Town of Parker Community Development Department
 Development Review Division
 Attention: **Stacey Nerger**

Application Type: **Site Plan**
 Status: **First Referral**
 Application Name: Crown Point F1 AMD30 L1 - Hospital Addition
 Case/AP#: **SP24-062**
 Referral Received: June 12, 2024
 Comments Due: July 11, 2024

TOWN OF PARKER FIRE/LIFE SAFETY:	R REVIEWED FOR CODE COMPLIANCE; REVISIONS REQUIRED
---	---

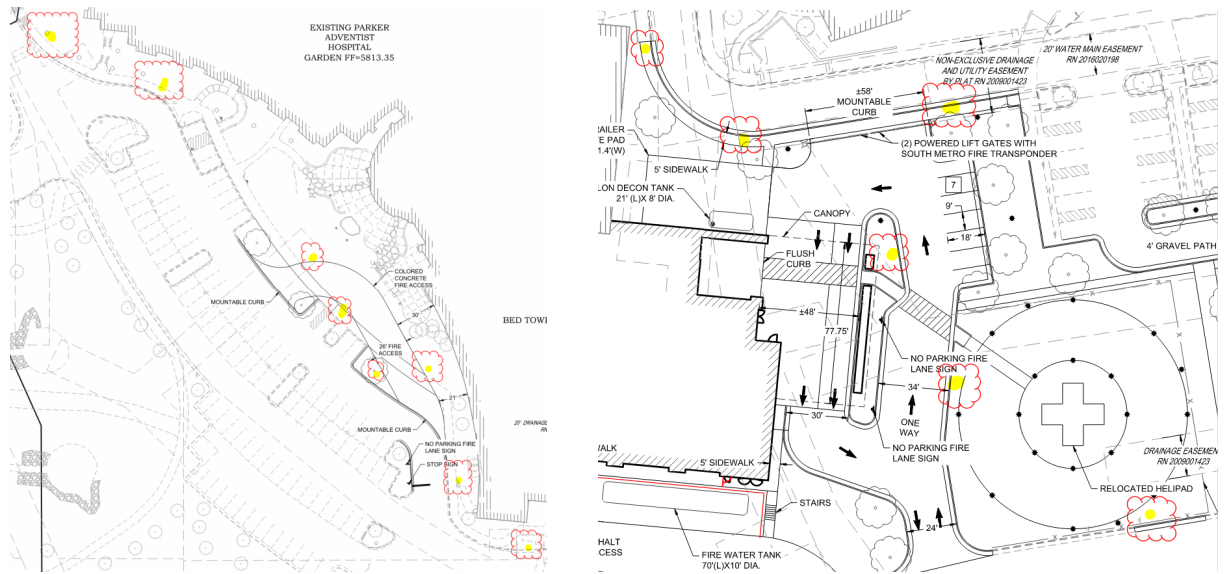
The applicant shall **provide a floor plan of how the riser room is to be laid out** to avoid conflicts with the site plan once the building review submittal has been made; this project will not be approved without this requirement having been met and approved.

- The domestic is not allowed to be pulled off of the underground fire line (UFL).
- The UFL is not allowed to share the same line as a fire hydrant.
- The UFL is not allowed to enter any further than 24-inches into the building (and any less than 12-inches into the building (as noted above) if applicable.
- The Utility drawings shall clearly identify the UFL by name, length and size on the plan set (a note can address this though the underground fire line itself shall also bear these notations. The measurement shall be made from the "T" at the water main ending at the flange in the fire sprinkler control valve room.

Due to the requirement to locate the riser room as discussed, the current fire location will likely be relocated to the watermain in the south private drive. Ensure that all issues noted above are addressed fully when resubmitting.

- RESPONSE: Please see the enlarged floor plan exhibit showing the proposed layout of the Fire Riser/Pump room and the Fire Command Center.
- RESPONSE: The Fire Life Safety signature block has been added on the cover sheet of the water and sanitary set (C500), along with the public works signature block.
